## SITE PLAN REVIEW

Project Name: Diomio's PIZZA

FILE #102-93

TITLE HEADING: Site Plan Review - Diorios Pizza

DOOR WINDOW ARCHWAY 5' 1/2" = 1 FT.  
 DIORIO'S 1125 NORTH AVE 243-1700

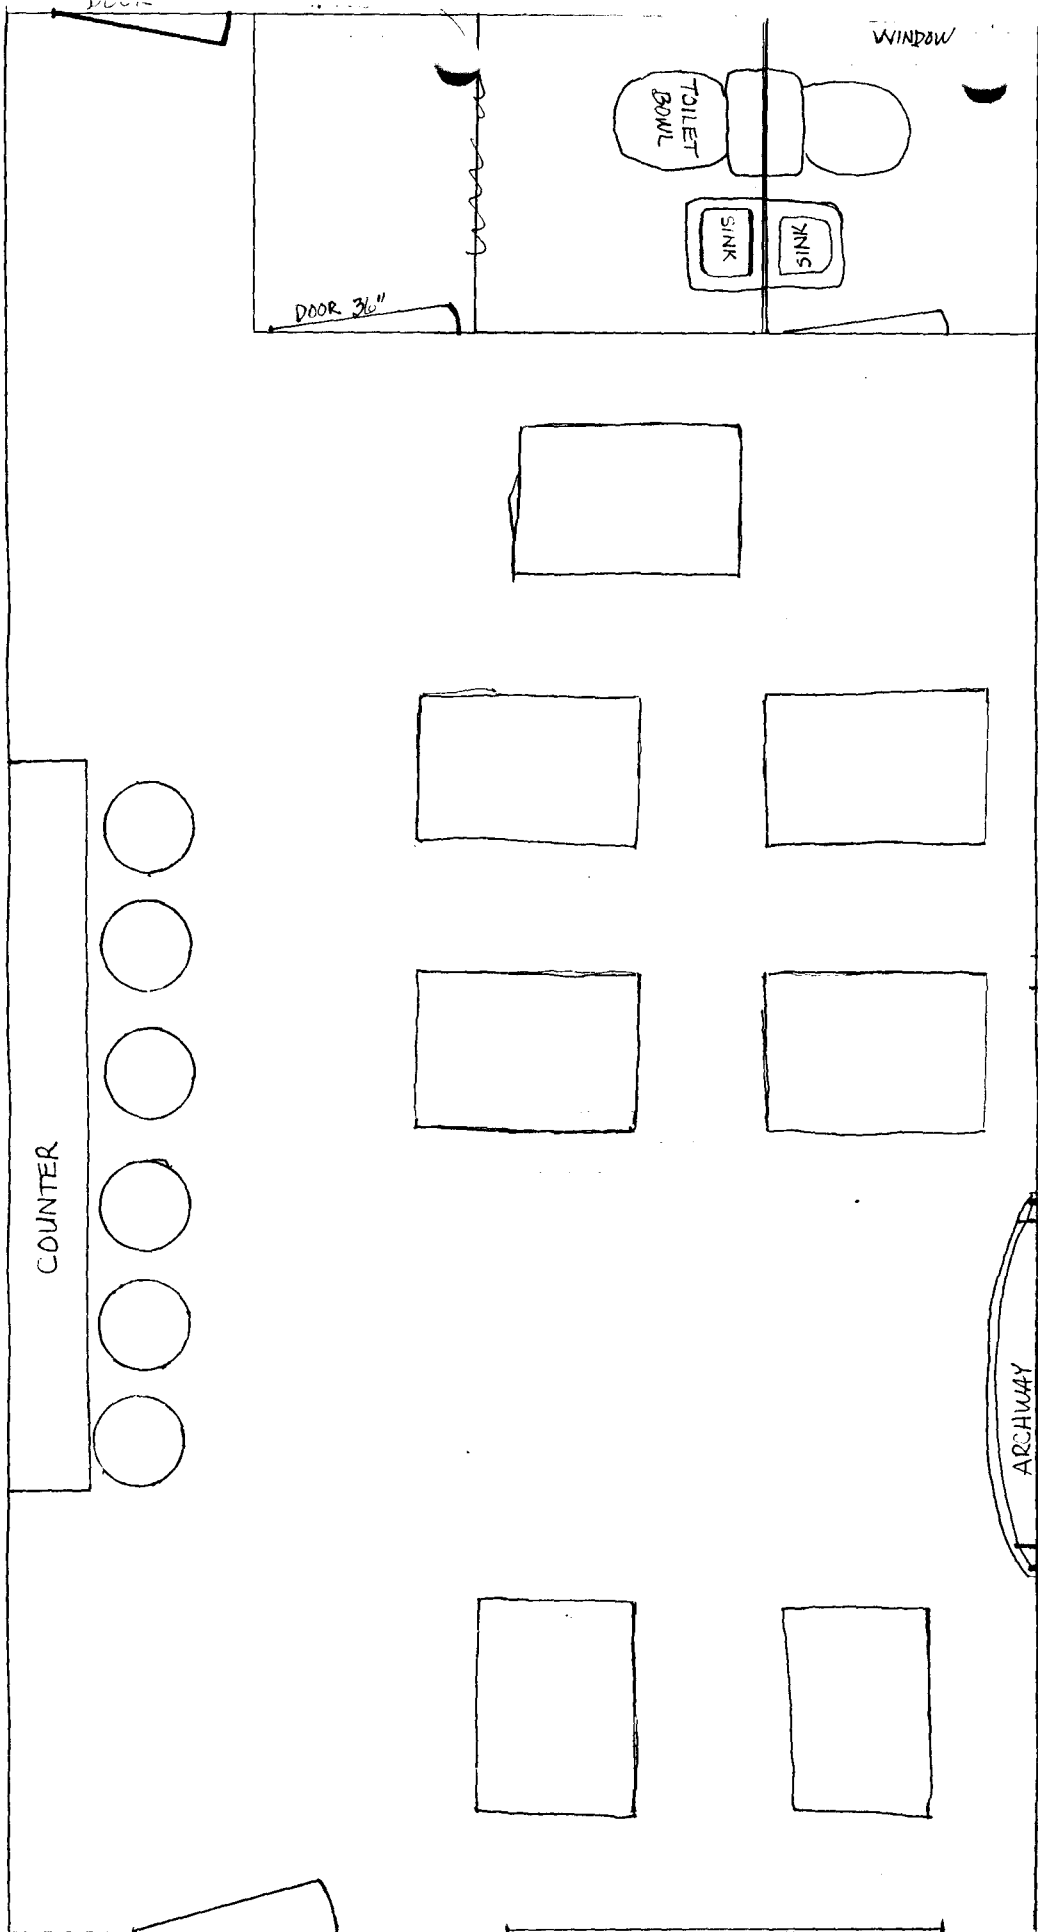
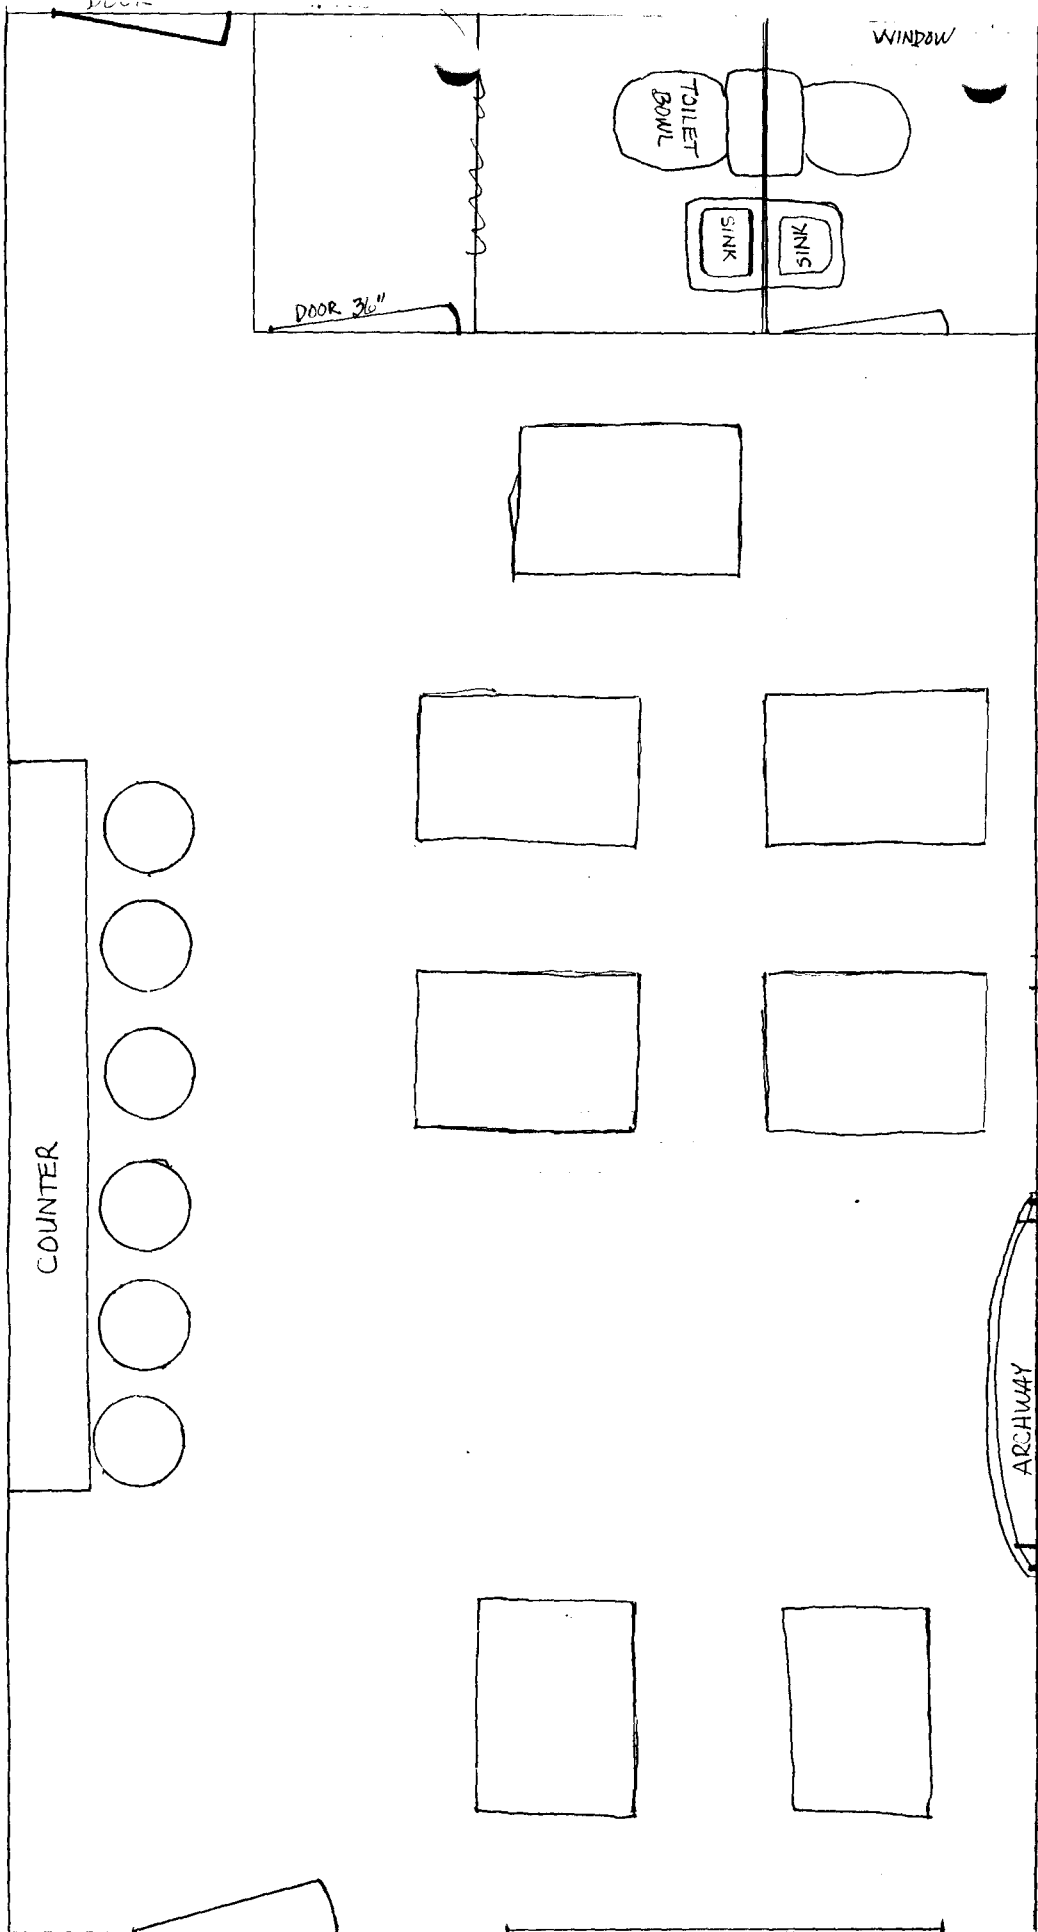
Our department will need to conduct an inspection of the property. There is insufficient information enclosed to make a determination on building code compliance of the new seating area. The applicant should contact us.

DIORIO'S  
1125 NORTH AVE. 243-1700

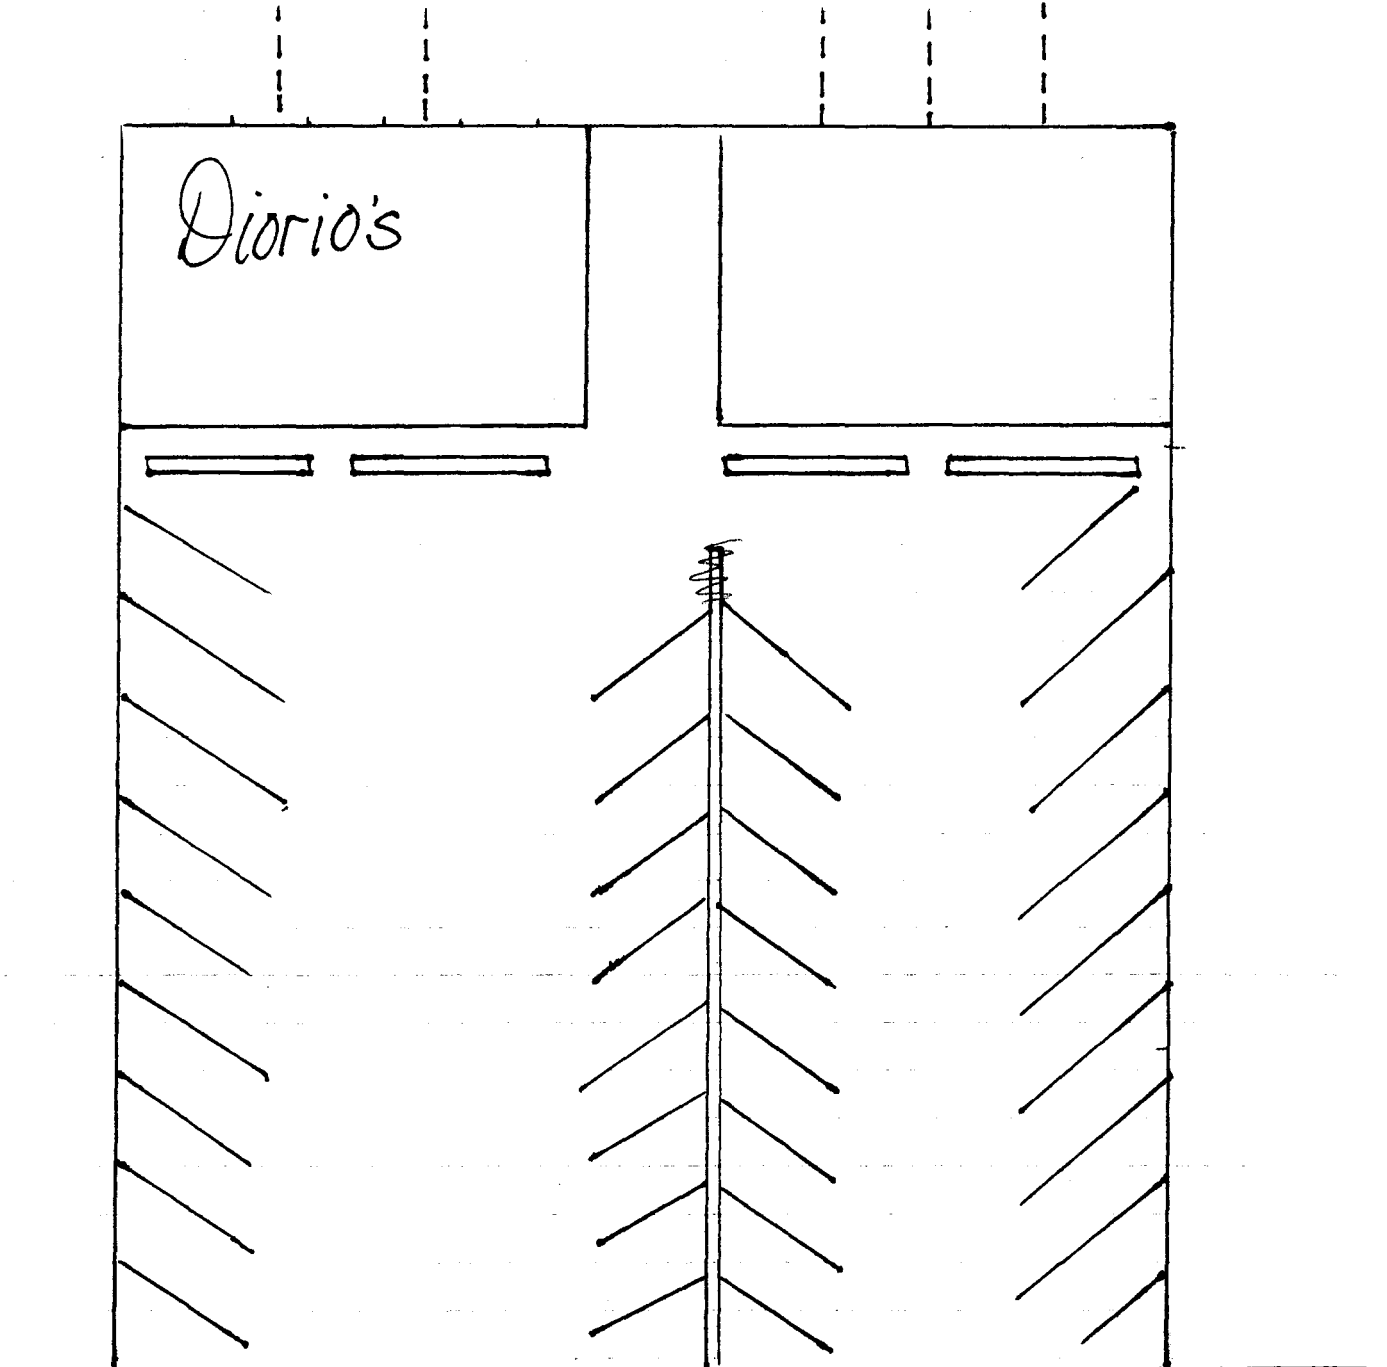
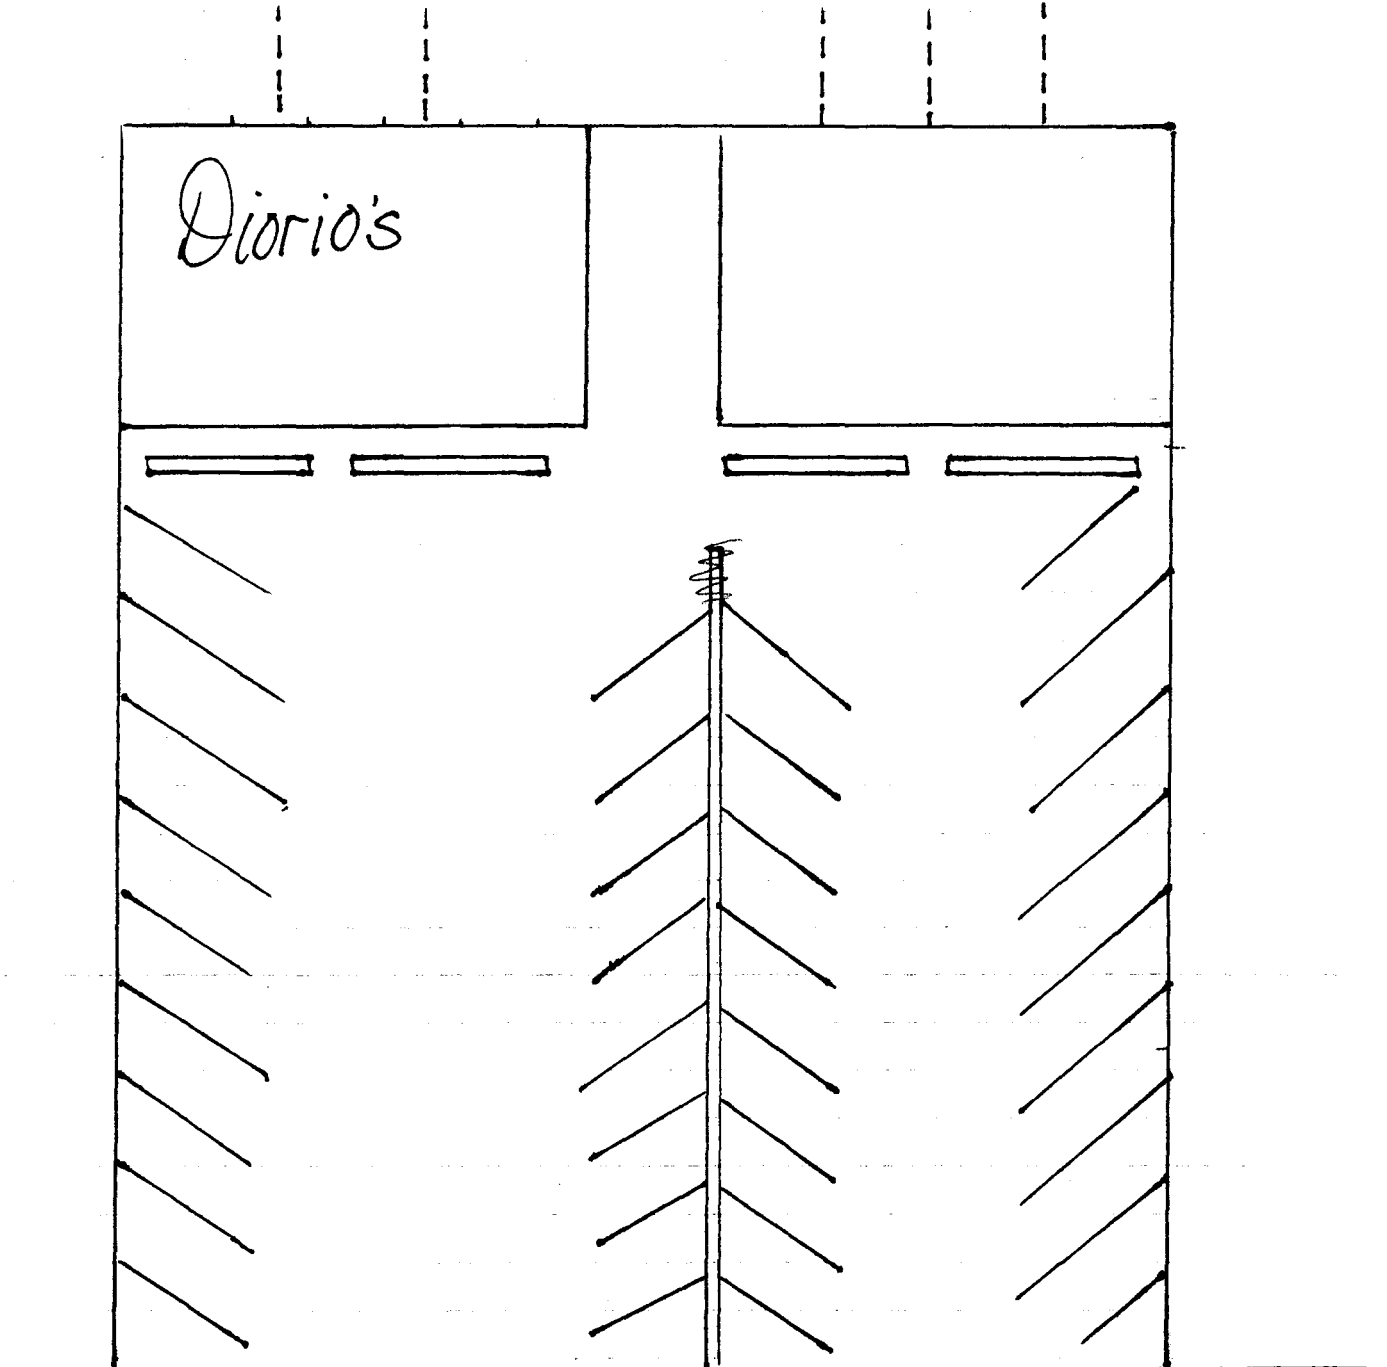
- To determine the parking requirement for the complex I need to know the square footage of the building with the 2 barber shops. The parking requirement for that building is 1 space per each 300 square feet of gross floor area. The requirement for the restaurant is 1 space per each 3 seats designed capacity. With a capacity of 32 seats the requirement is 11 spaces.
- The parking lot as it is currently designed is difficult to maneuver through and does not meet code. It should be restriped so that the west driveway is an entrance only and the east driveway an exit only with the spaces angled accordingly (see attached sketch and standards). The concrete curb in the middle would also need to be shortened to allow easy access around it. The entrance and exit should be signed as such.
- Please submit a revised drawing and information on the square footage of the other building.
